NOTICE OF DATA INACCURACY

INSPECTION REPORT

Electrical Corporation:	Southern California Edison Company
Report Number:	PAD_SCE_SIS_20261007_1023
Date of Inspection:	October 7, 2026
City and/or County of Inspection:	Yucaipa, San Bernardino County
Inspector:	Samuel Isaiah
WMP Year Inspected:	2026
Quarterly Data Report (QDR) Referenced:	Quarter 2 (Q2)
Inspection Selection:	Energy Safety viewed the contents of the Q2 QDR and performed an analysis that resulted in the selection of the WMP initiatives and locations referenced in this report.
Relevant WMP Initiative(s):	8.2.1.1 – WCCP Covered Conductor
Inspection Purpose:	Assess the accuracy of Southern California Edison Company's QDR data, completeness of its work, and performance of WMP requirements.

Data Inaccuracy 1

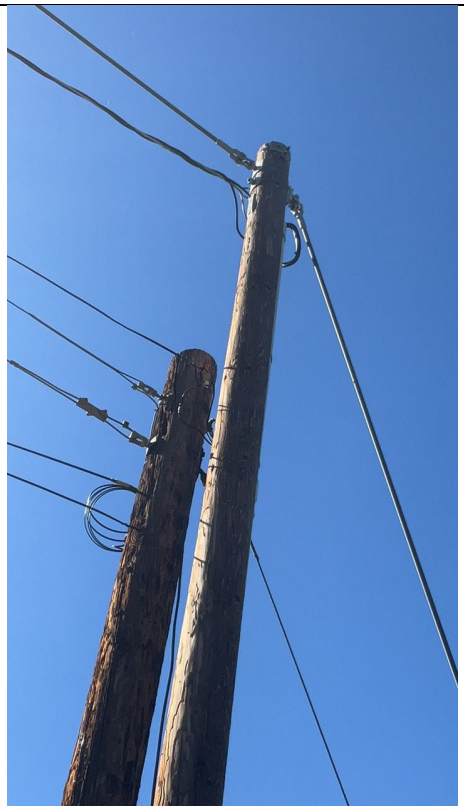
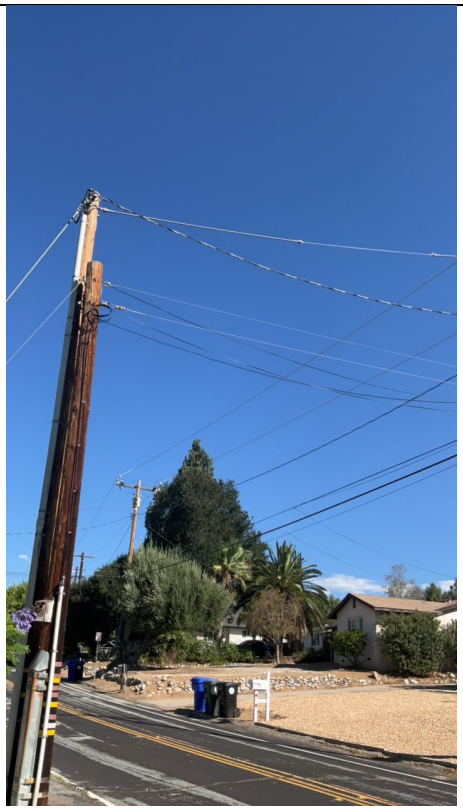
On Structure ID 4680049E, Grid Hardening ID TD2357977-4680049E at 12282 Fremont St, Yucaipa, CA, 92399, USA, coordinates 34.0303981668504, -117.027191402102, the inspector observed that SCE failed to provide accurate data on covered conductor installation initiative. The inspector's observation is documented in Data Inaccuracy 1 photographs, which are attached to this report as Exhibit A.

1. SCE reported in the 2026 Q2 QDR that work on WMP initiative 8.2.1.1 – WCCP Covered Conductor was completed at this location.
2. In 2024, SCE informed Energy Safety that stub pole work does not count toward Covered Conductor WMP totals and would either identify or exclude these points in future QDRs. This data point did not contain an identifier and was not excluded.
3. No covered conductor was observed.

Asset Image 1: No covered conductor observed	**Asset Image 2**: No covered conductor observed

Within 30 days from the issuance date of this NODI, SCE should provide a response advising Energy Safety of corrective actions taken or planned to remedy the identified data inaccuracy or inaccuracies.
